## ***Burlington Comprehensive Development Ordinance***

### ***PROPOSED: ZA-16-?? – Downtown Mixed Use Core Overlay***

*As proposed by the Planning staff – May 4 2016.*

Map 4.2.2-1 Official Map of the Downtown and Waterfront Core ~~Waterfront Core Official Map~~

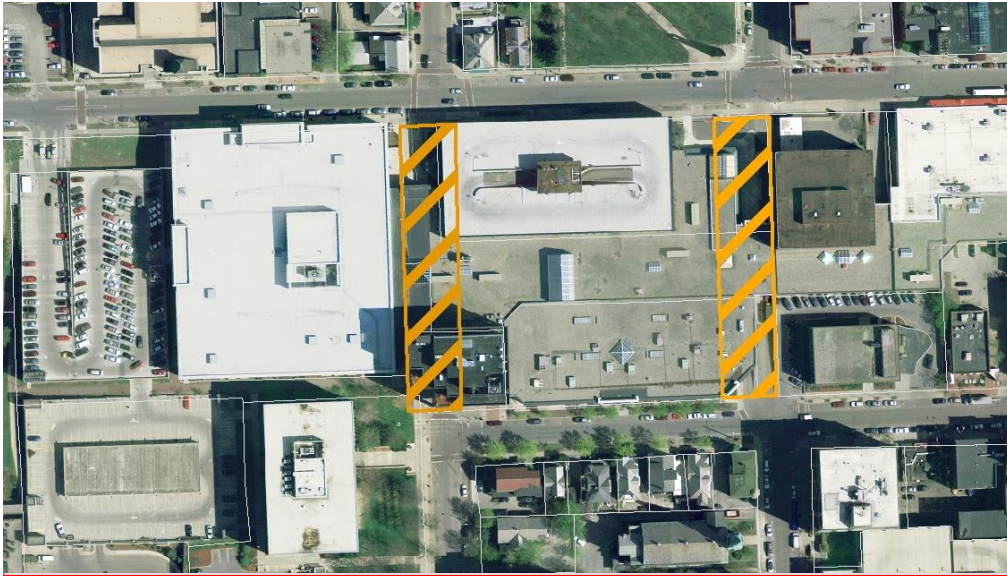
- (h) The re-establishment of St Paul Street between Cherry and Bank streets as a public street with a right-of-way sixty (60) feet in width to accommodate pedestrians, bicycles and vehicles; and.

- (i) The re-establishment of Pine Street between Cherry and Bank streets as a public street with a right-of-way sixty (60) feet in width to accommodate pedestrians, bicycles and vehicles.

**Comment [DEW1]:** This will ensure that the proposed north-south connectivity on Pine and St. Paul streets envisioned in planBTV is accomplished. The City will have 120-days to initiate proceedings to acquire any land within this area that may be proposed for new development. As proposed, the BTC will comply.

**Comment [DEW2]:** These proposed new ROW's are consistent with the BTC project as proposed

Figure 4.4.1-2 Measuring Height Limits for Church Street Buildings

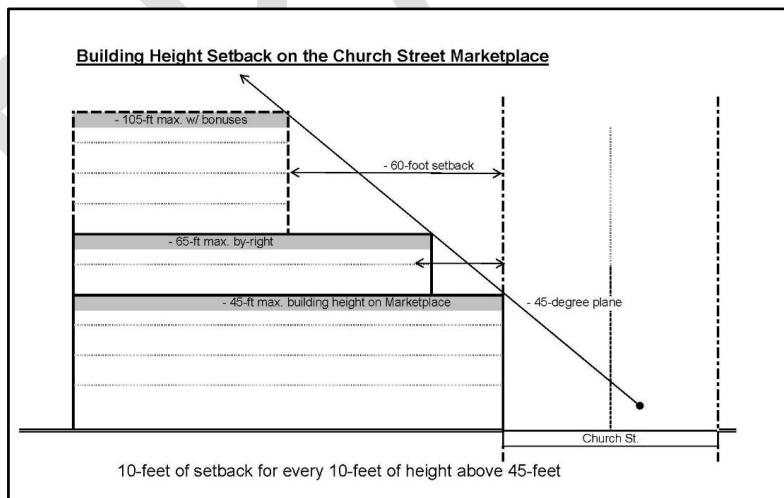
For the purposes protecting the historic character and scale of buildings along the Church Street Marketplace, the maximum height of any building fronting on Church Street shall be limited to ~~38 feet~~ **4-stories not to exceed 45-feet**. Any portion of a building ~~within 100 feet from the centerline of Church Street exceeding 45-feet~~ shall be set-back a minimum of ~~46~~ **10**-feet for every 10-feet of additional building height above ~~38~~ **45**-feet.

**Comment [DEW3]:** While outside of the proposed new overlay, this change is already envisioned as part of the currently proposed form-based code to provide better compatibility of building heights on Church Street. The BTC project as proposed will need its upper floors to be set back farther in order to comply

Map 4.5.8-1: Downtown Mixed Use Core Overlay (DMUC) district

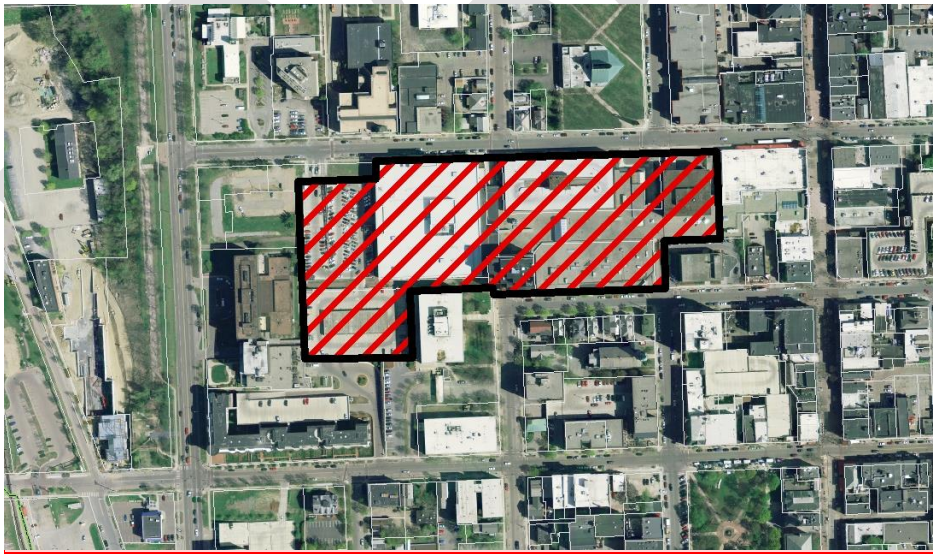
The Downtown Mixed Use Core Overlay (DMUC) district includes those portions of the Mixed Use Downtown (D) District as delineated on [Map 4.5.8-1](#).

**Comment [DEW4]:** Boundary of this area needs to consider existing and potential development in this area which has generally been supported in planBTV and by the Joint FBC Committee as the part of the downtown where greater height could be appropriate.
